Sumter City-County Planning Commission

March 23, 2011

SD-11-01, Osteen Tract Phase 1 – Old Camden Highway (County)

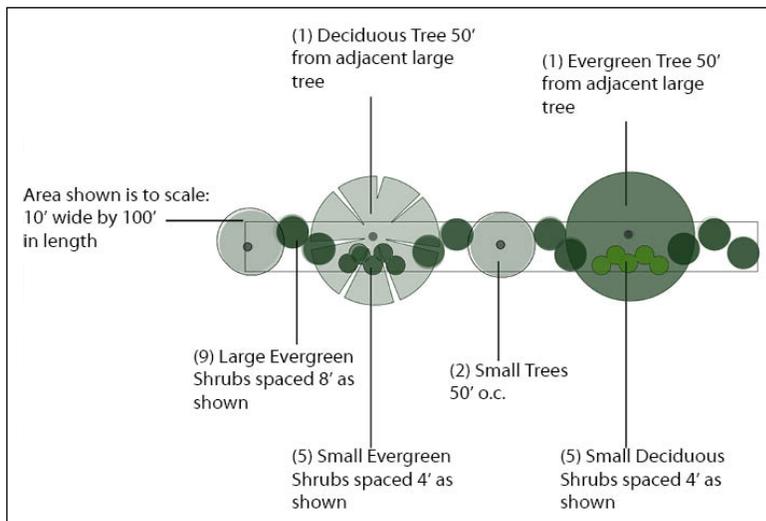
When this tract was rezoned from AC to R-6, neighboring property owners expressed concern about the change in density and requested that sufficient landscaping be provided to buffer the new higher density development from their existing dwellings. As shown in the graphic to the right, the areas indicated in green should be planted with a 10 ft. evergreen buffer strip that will attain a height of at least six feet (6 ft.) over three growing seasons.

Planning Staff recommends that the 10 ft. buffer strips indicated in green in the graphic above be shown as a landscape easement on the final plat and that the plantings be comprised of the following:

- 1) Submission of a comprehensive landscape plan that addresses a 10 ft. landscape buffer in the areas indicated on page 4 of this report, as well as the retention pond area. All buffer areas shall be shown as landscape easements on the final plat.
- 2) Reconfiguring the existing parcels to increase the lot widths of lots #1 and #12 with the implementation of an easement on the exterior sides of the parcels in order to accommodate future right of way expansion.
- 3) Indicate future access point on the final plat showing possible connection to development on the remaining acreage.

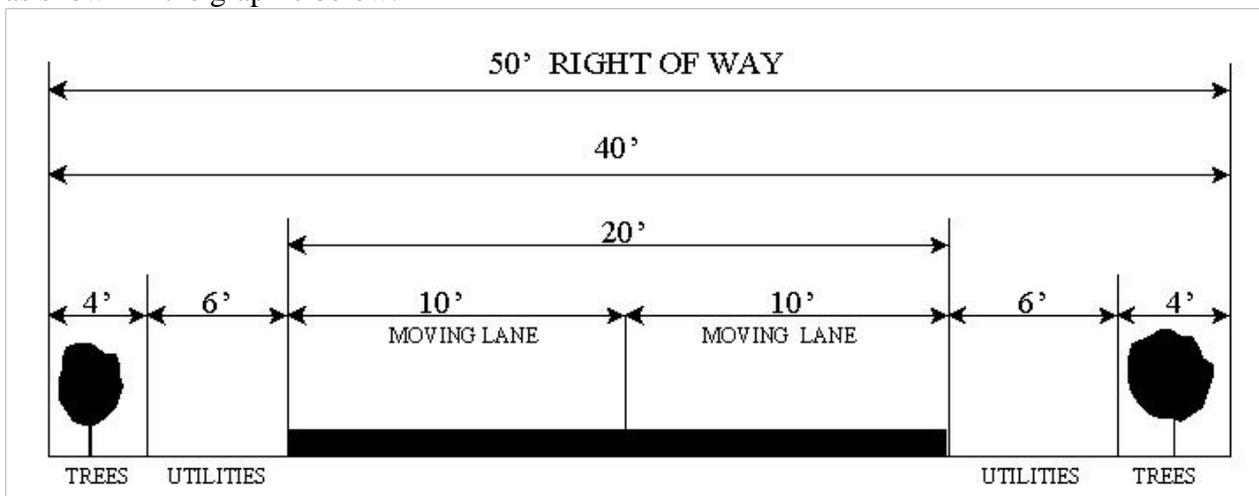
The planting scheme shown to the left creates a border that gives privacy, screens the back yard and adds visual interest and natural beauty.

The small evergreen shrubs are to be planted in groups of 5 in front of the deciduous large tree, and conversely the deciduous small shrubs are intended to go in front of the large evergreen trees. This planting plan is predicated

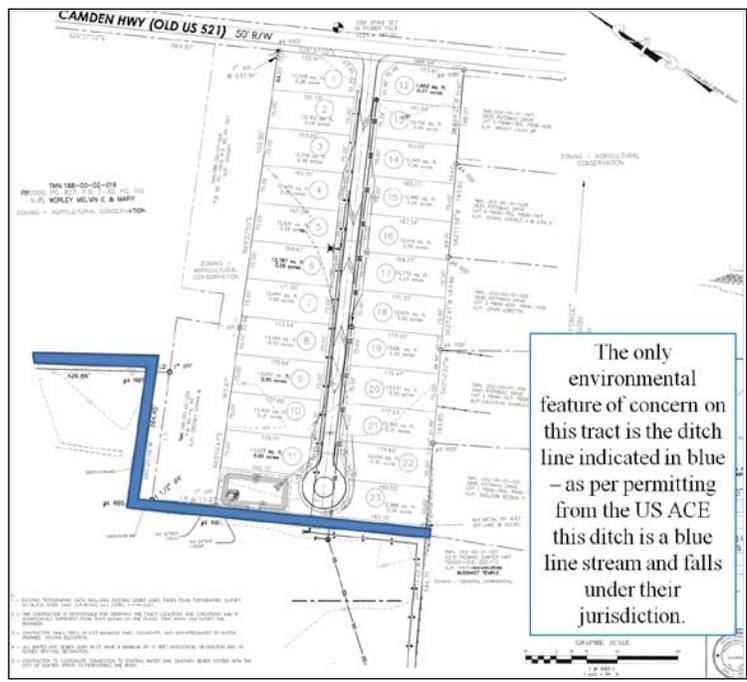
There is an existing ditch-line, shown in blue in the graphic on the right, that has been deemed to be a Blue Line Stream and is under the jurisdiction of the U.S. Army Corps of Engineers (US ACE). Proposed development plans require a sewer and water line to cross this water body and as such, proper permitting must be obtained through the US ACE. On March 8, 2011 the applicant's representative provided Planning Staff with documentation from the US ACE and the South Carolina Department of Health and Environmental Control (DHEC) showing that they have been permitted to temporarily impact 12 sq. ft. of waters of the US pursuant to Nationwide Permit 12 (Utility Line Activity). No additional activity is permitted with respect to the ditch. Anything beyond the scope of the existing approval must receive new review and approval from the US ACE.
